**GOVERNMENT OF THE DISTRICT OF COLUMBIA  
DEPARTMENT OF TRANSPORTATION**

**MEMORANDUM**

**SUBJECT:** **DDOT Report for BZA Case 18531, Heritage Foundation, Maryland Avenue, NE**

Figure 1: Proposed Site Layout and Access.

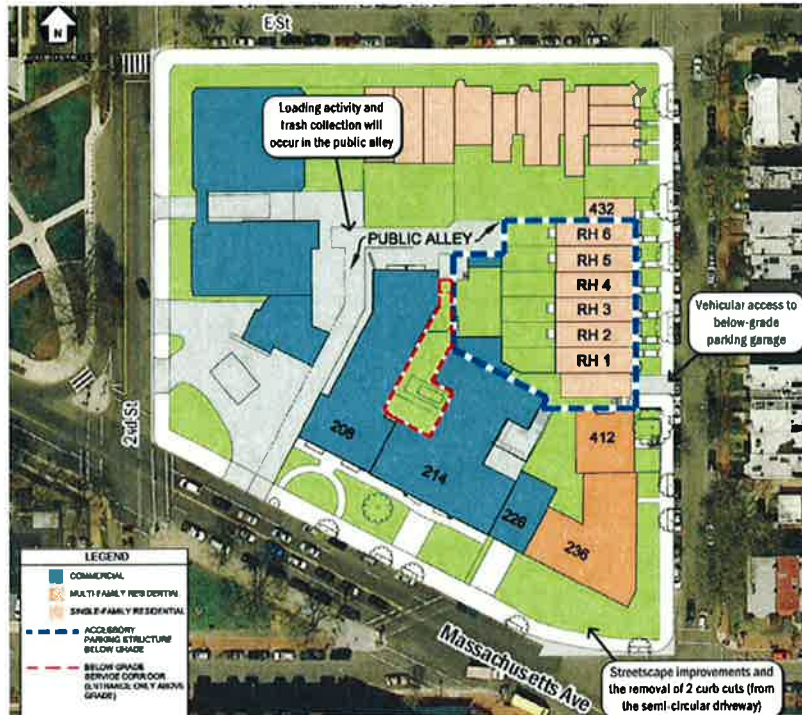
As shown in Figure 1, the Applicant is proposing a parking garage, accessible from 3<sup>rd</sup> Street, NE. The parking garage will serve vehicles for the six row houses along with commercial/office portion of the project, directly associated with the Applicant's activities. The parking garage will serve vehicle parking and long-term bicycle parking for commuters. The parking garage driveway is proposed to be full access. Pedestrian access to the Heritage Foundation and its accessory buildings is via Massachusetts Avenue. Loading and all trash collection is proposed from a 10' public alley, directly west of 208 Massachusetts Avenue. Trash collection associated with row houses will be through the parking garage to the public alley behind 208 Massachusetts Avenue.

Finally, 236 Massachusetts Avenue currently has two curb cuts that serve a circular driveway. The Applicant is proposing to eliminate these access points as part of its landscaping plan. DDOT supports the closing of this circular driveway as it eliminates two vehicle conflict points in a heavily pedestrian-traveled area.

DDOT has concerns about the effect of moving the existing 3<sup>rd</sup> Street driveway on the tree canopy. The Applicant should utilize the existing curb cut on 3rd Street NE and protect the adjacent street tree canopy. Removal of a healthy street tree and tree box requires approval by the Ward 6 Arborist. In addition, widening of existing street tree planters and planting of new trees in the public right of way is encouraged by DDOT. DDOT will address these concerns and any other public space design issues during the public space permitting process.
